August 25, 2014

Mr. Anthony Hood, Chairman
Zoning Commission of the District of Columbia
441 4th Street, NW, Suite 200-S
Washington, DC 20001

Re: Zoning Case 13-14
Vision McMillan Partners, LLC & DC Deputy Mayor for Planning and Economic
Development

Existing Condition - Meadow

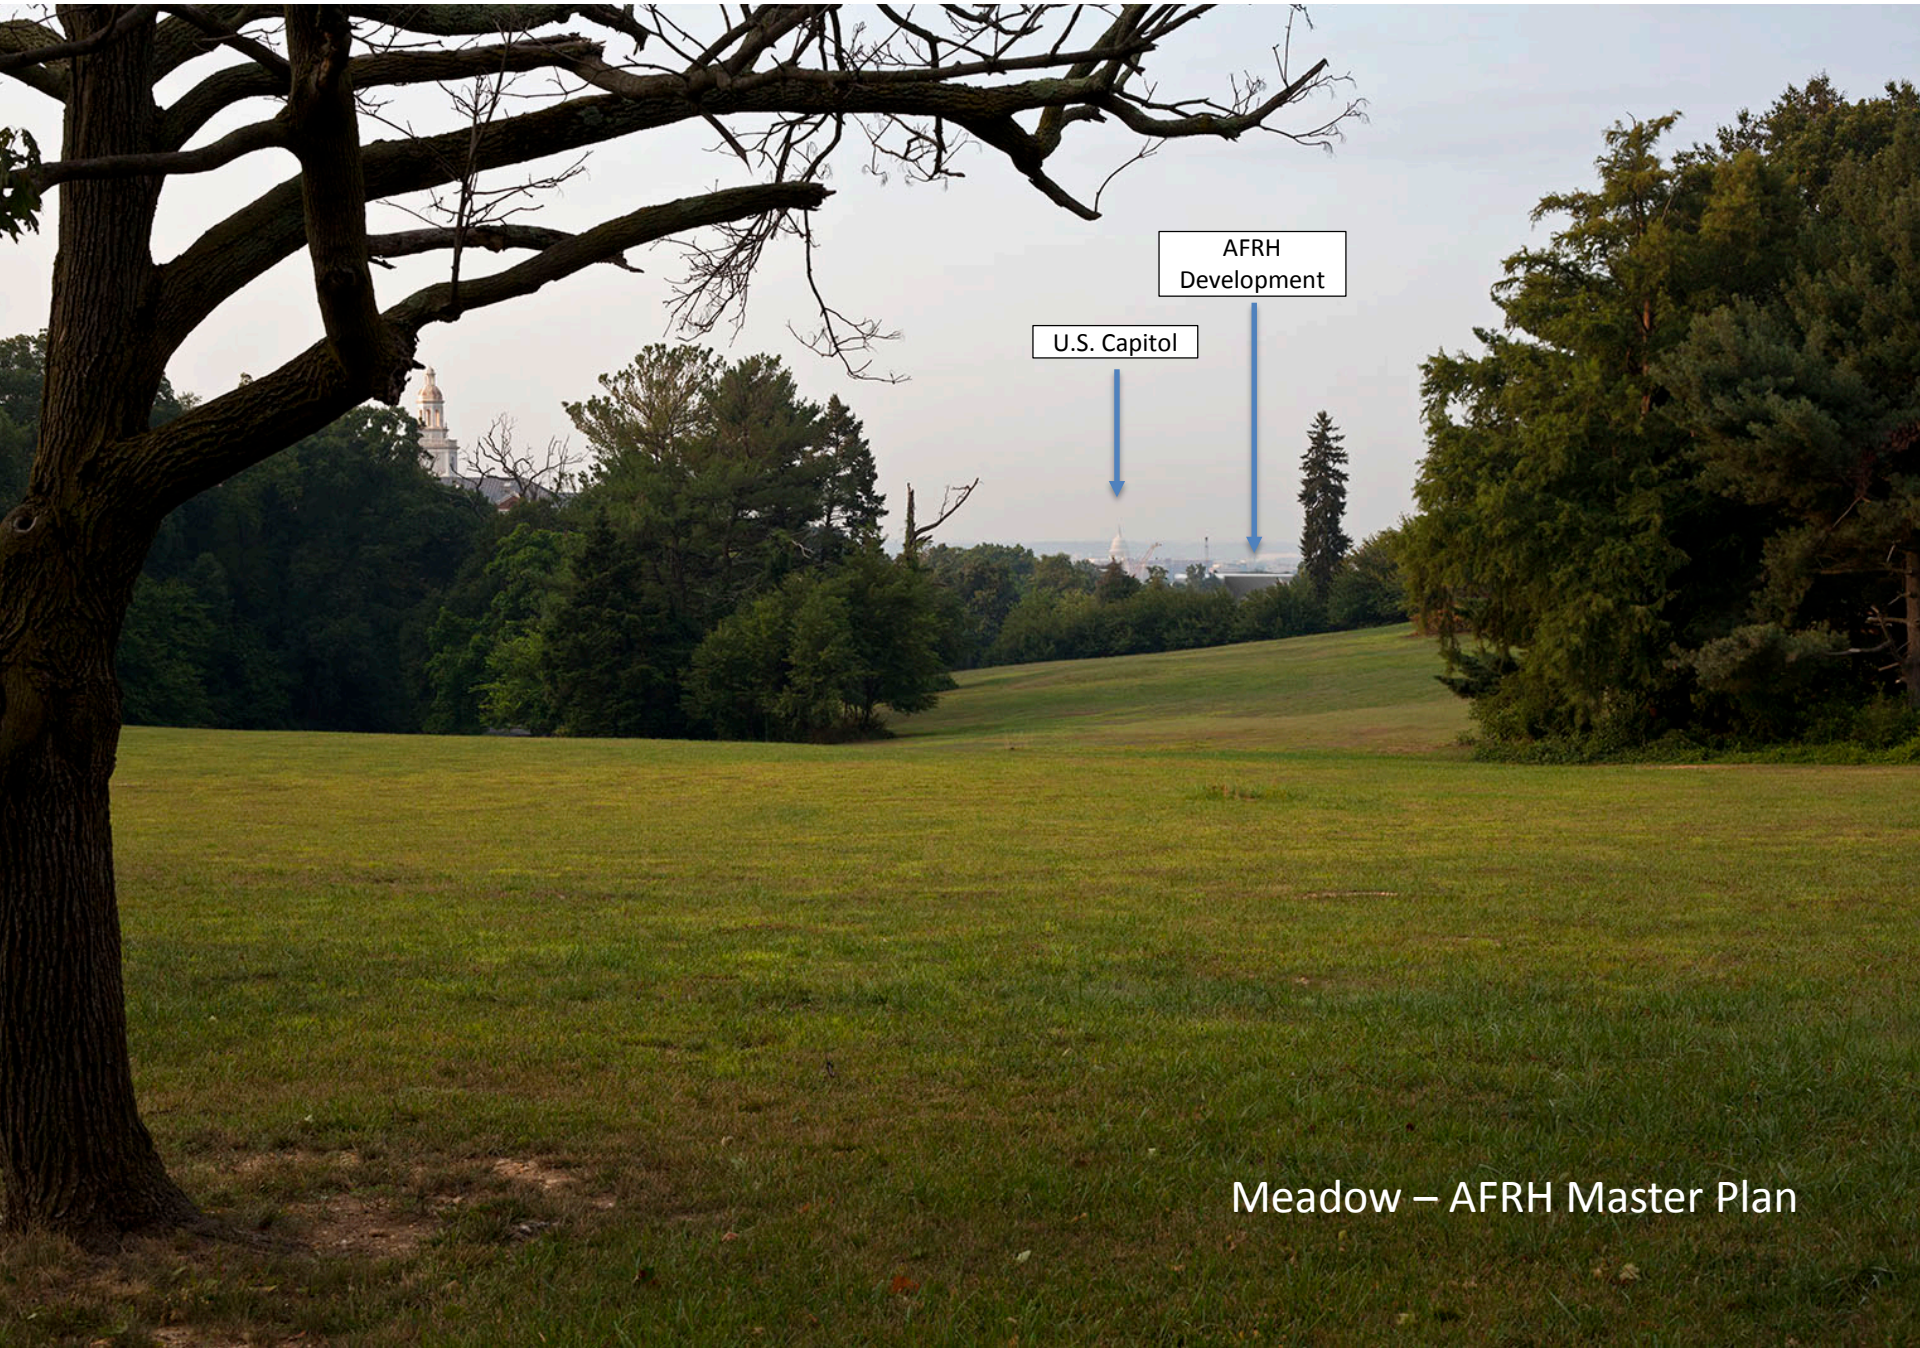
The existing view from "The Meadow" currently is focused on the U.S. Capitol, framed by two stands of mature vegetation (Attachment B). From this vantage point, the U.S. Capitol Building can be seen against the horizontal backdrop of the topographic bowl that surrounds Washington. As demonstrated in the modeling, the permitted building heights within the AFRH-W Master Plan retain this view, while the proposed McMillan development would completely block the view even at the modified height of 115 feet. In fact, the modeling shows that this view would still be significantly diminished even if building heights were reduced to 100 feet.

Therefore, NCPC staff recommends that the Zoning Commission request the applicant to submit a development scheme that considers views from the AFRH-W to the same extent taken by the Federal and District Government during development of the neighboring AFRH-W and VAHC master plans, and is more consistent with the Comprehensive Plan land use categories currently assigned to the site.

Meadow – AFRH Master Plan + McMillan Development

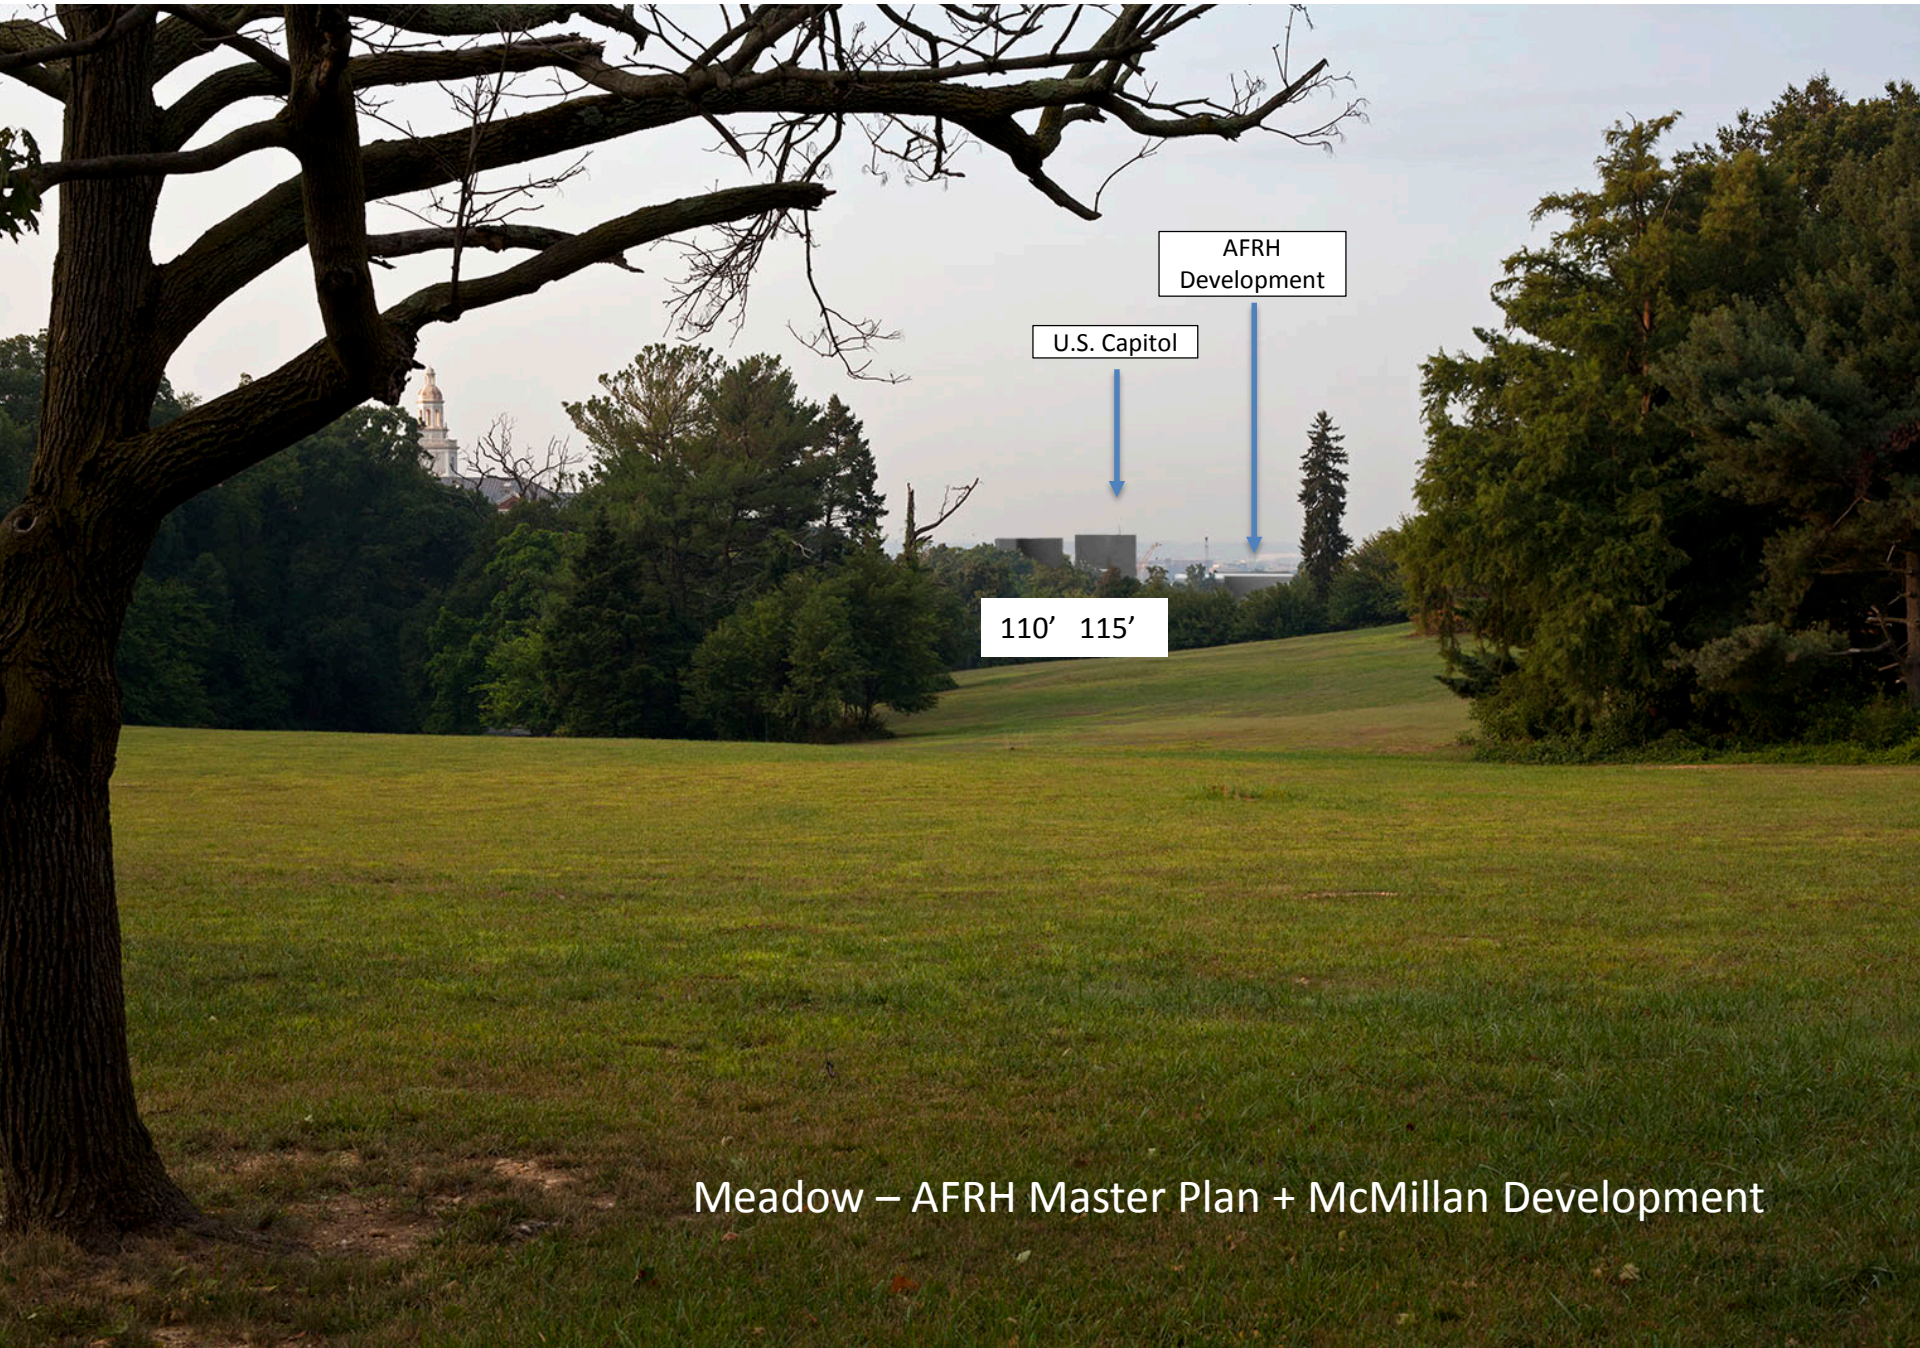
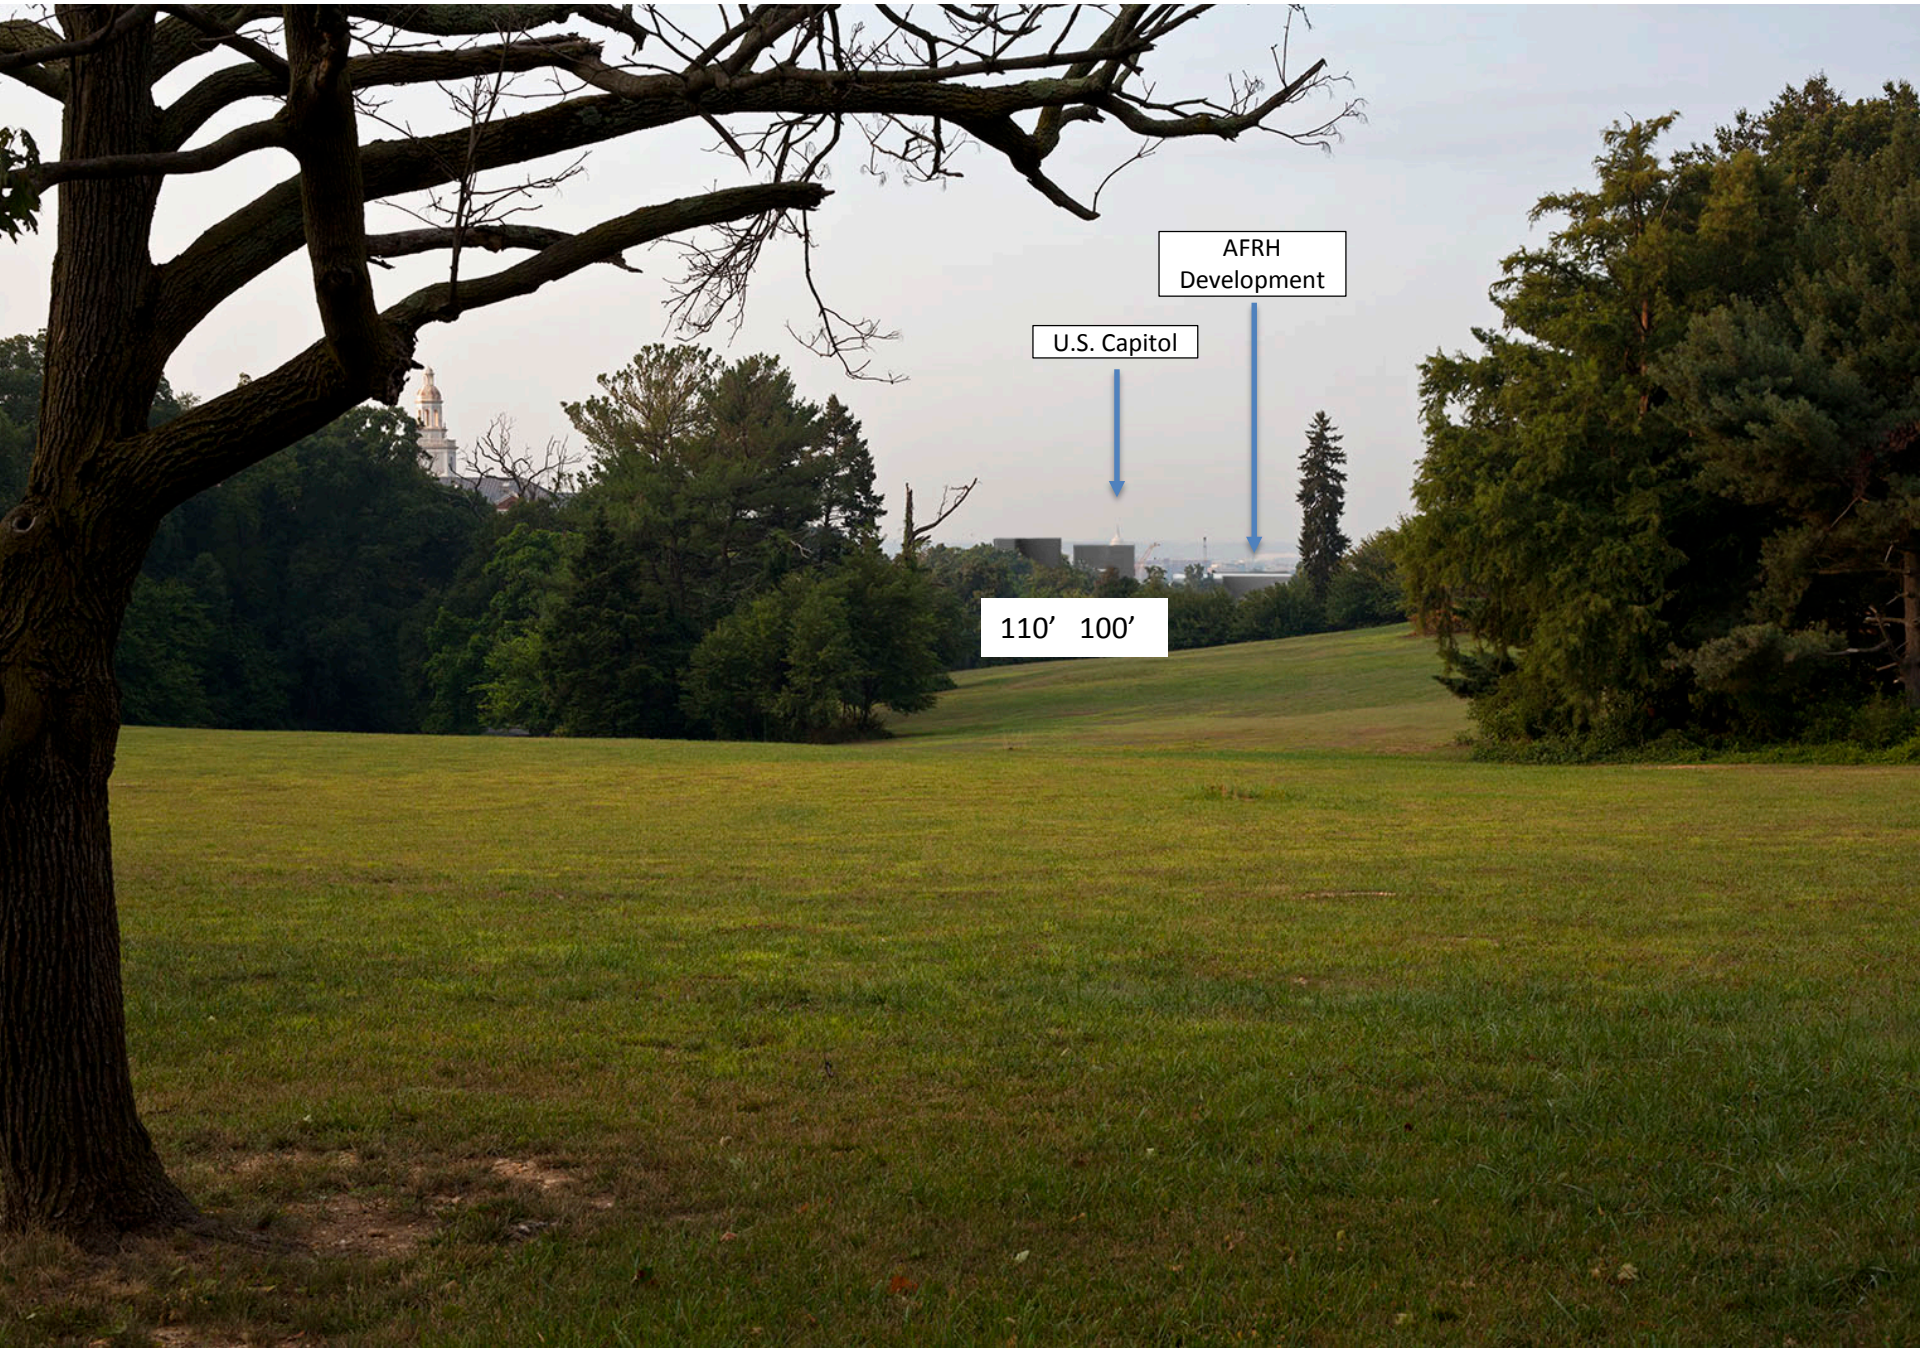
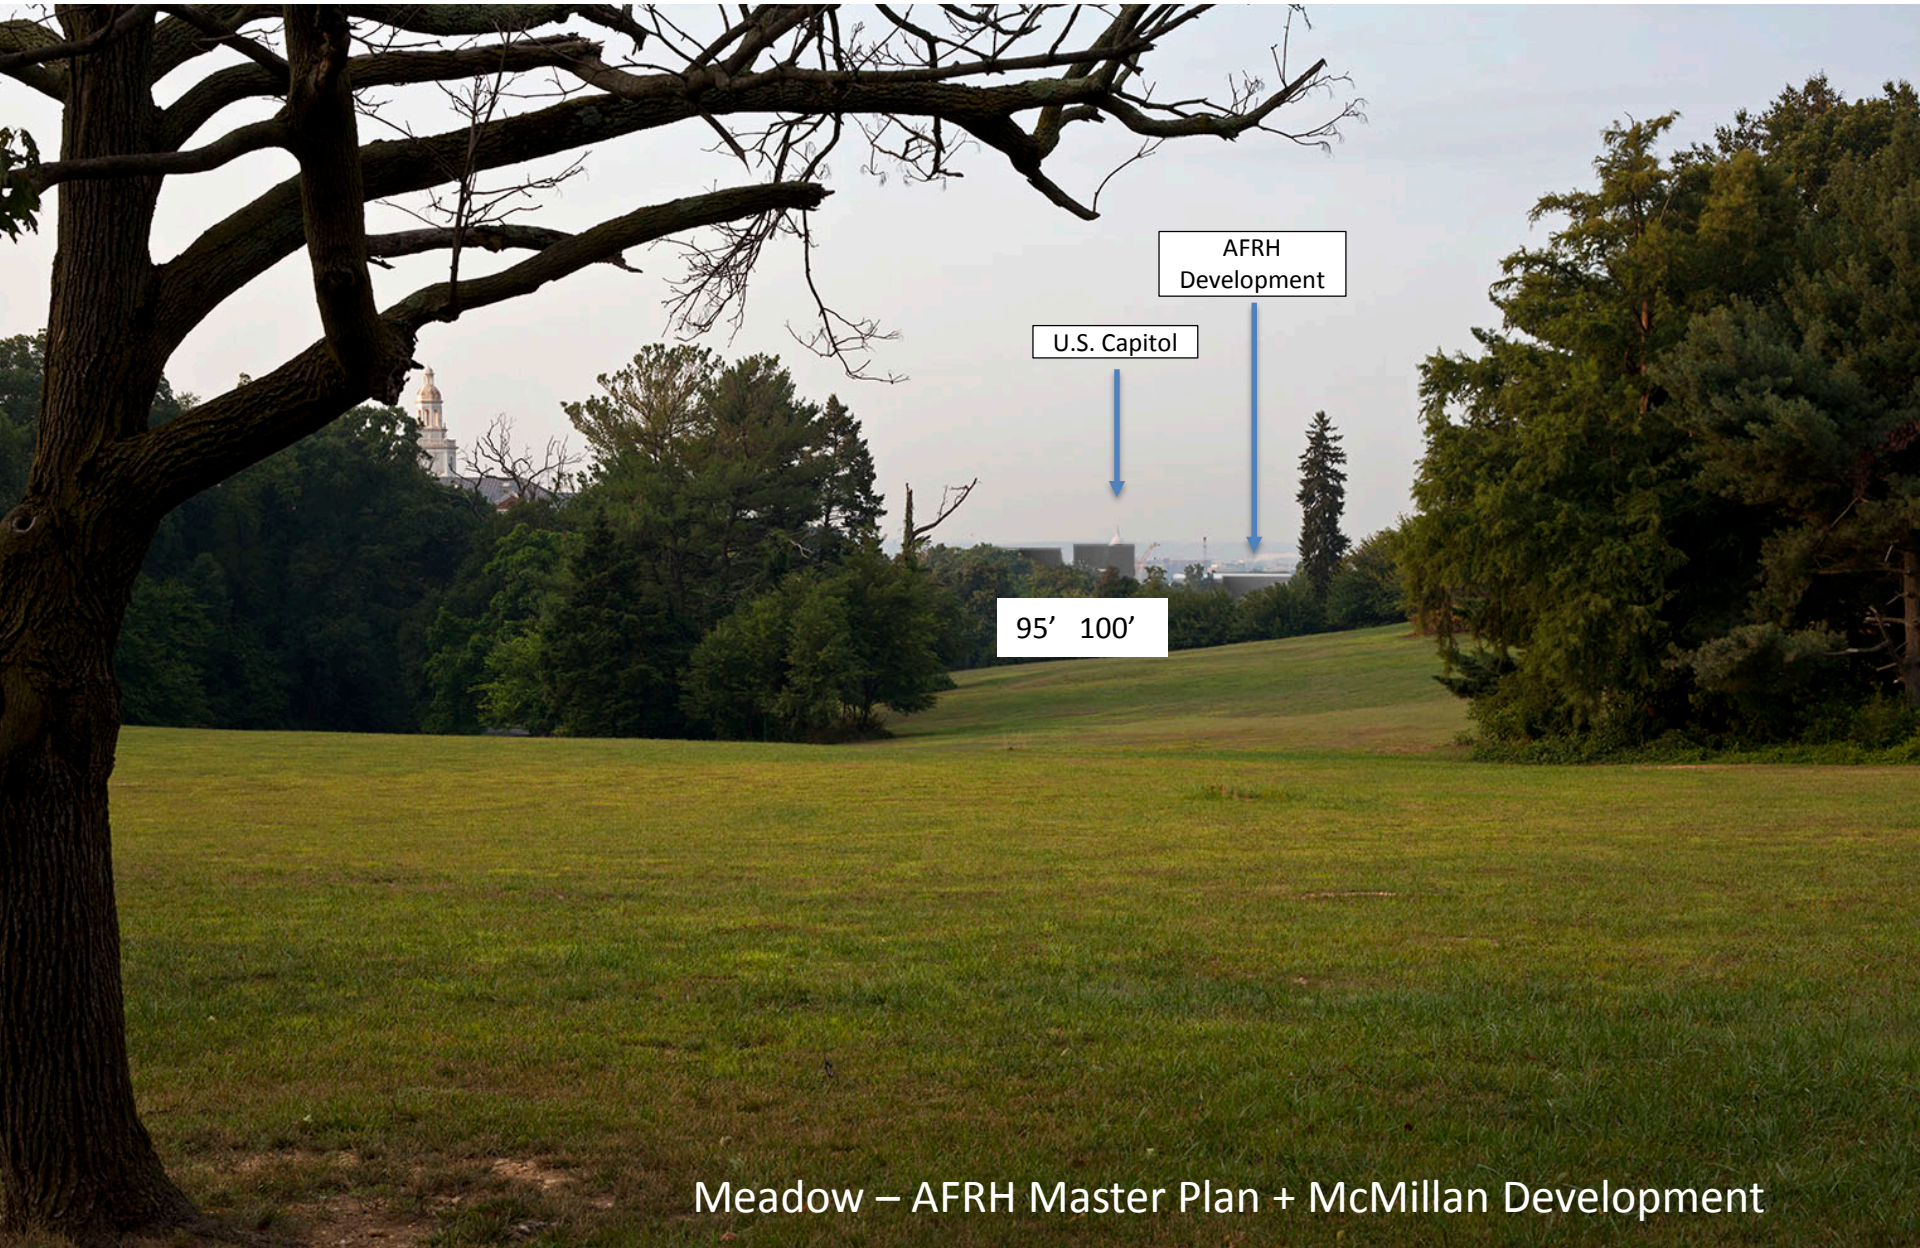
As shown in the modeling study, due to the careful attention paid to building heights by the Federal and District Governments during the AFRH-W Master Plan process, future development along the south boundary of the Campus will retain the character of this view. At maximum heights ranging between 65 - 75 feet within the viewshed, development along the south boundary of the Campus will maintain the full view of the U.S. Capitol dome atop its building base against the horizontal backdrop. In contrast, if constructed as currently proposed, the McMillan development would significantly alter the view from Scott Statue by blocking the view of the U.S. Capitol dome and disrupting the character defining horizontal backdrop established by the topographic bowl (Attachment D). As the modeling shows, these impacts would occur even if building heights were reduced to 100 feet.
